Product Equality Declaration

We, MUNIC, declare for the product **C4FLEX-4MUSAA_V8** that we accept the components' alternatives mentioned below and that they were tested for FCC compliance:

Model: C4FLEX-4MUSAA_V8
FCCID: A6GC4FLX-4MUSAAV8
Hardware version: HC4FLEX-4MUSAA_V8.01

Figure 1: Module shield alternative 1

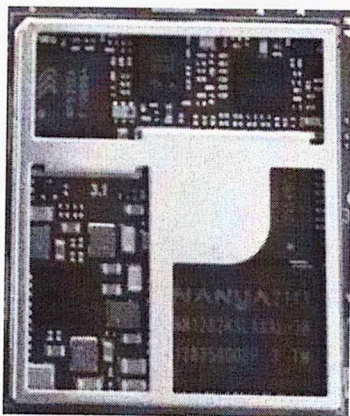
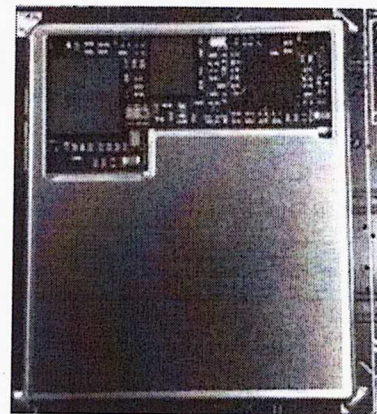
Difference description: Modules are the same part with different shield frames (per PCN n°2021020706 provided by the module manufacturer: Quectel). For more details, please refer to the below figures.
